Original draft text	Comments/Proposals	Discussion Outcome(s)
1	Introduction		
2	In 2015, the World Forum for Harmonization of Vehicle Regulations (WP.29) established a programme under the Intelligent Transport Systems (ITS) informal working group to focus on automated driving (ITS/AD).		
3	During its 174 th (March 2018) session, WP.29 approved a proposal from the ITS/AD informal group for a “Reference document with definitions of Automated Driving under WP.29 and the General Principles for developing a UN Regulation on automated vehicles”. ¹		
4	In March 2018, ITS/AD established a Task Force on Automated Vehicle Testing (TFAV) “to develop a regulatory testing regime that assesses a vehicle’s automated systems so as to realise the potential road safety and associated benefits under real life traffic conditions”. ²		
5	TFAV established subgroups to consider AV assessment methods: <ul style="list-style-type: none"> • Physical certification tests and audit • Real-world test drive.

Original draft text	Comments/Proposals	Discussion Outcome(s)
6	<p>In October 2018, TFAV proposed creating an informal working group on Validation Methods for Automated Driving (VMAD) “to develop methods to a

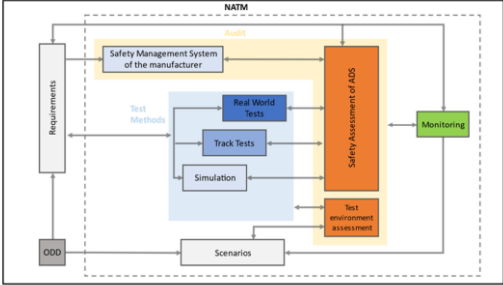
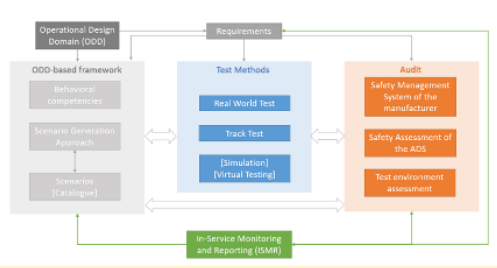
116	These pillars are intended for use in combination(s) to produce an efficient, comprehensive, and coherent assessment of ADS compliance with the guidelines on safety performance. Figure [1] below illustrates relationships across the ADS safety requirements, ODD analysis and scenario generation, and the validation pillars.	<p>UK comment</p> <p>Some commentary around the links on this diagram would be helpful.</p>
